**Work Order ID 52149**

Item Name: Skidtube RH

# **DART SERVICE INSTRUCTION**

**TO AMEND INSTALLATION INSTRUCTIONS IIN-D209-669 REV. B**

# 5.0 PARTS LIST

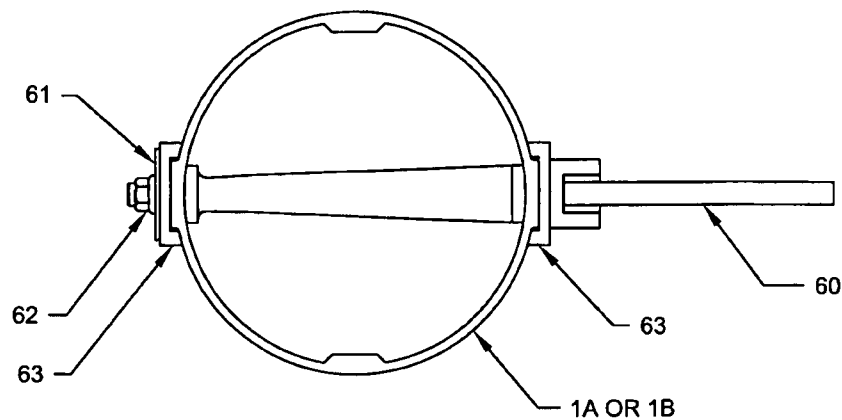
- a) REPLACE THE D2968-041 TOW RING WITH THE D3407-041 TOW RING ASSEMBLY.
- b) REPLACE THE D2736-1 AND D2736-3 GHW LUGS WITH THE D3405-041 AND D3405-043 LUG ASSEMBLIES.
- c) AMEND THE PARTS LIST IN SECTION 5.0 OF INSTALLATION INSTRUCTIONS IIN-D209-669 REV. B AS SHOWN ON PAGE 2 OF THIS DSI.

NOTE: ALL INSTALLATION FASTENERS FOR THE ABOVE CHANGES HAVE BEEN UPDATED. SEE THE AMENDED PARTS LIST ON PAGE 2 FOR DETAILS.

50	4	4	1	1			D3405-041	LUG ASSEMBLY
51	8	8	4	4			AN4C47A	BOLT
52	16	16	8	8			D2570	BUSHING
53	8	8	4	4			MS21043-4	NUT
54			1	1			D3405-043	LUG ASSEMBLY
60	1	1	1	1			D3407-041	TOW RING ASSEMBLY
61	1	1	1	1			D3456-1	WASHER
62	1	1	1	1			MS21043-4	NUT
63	2	2	2	2			D3417-5	WASHER
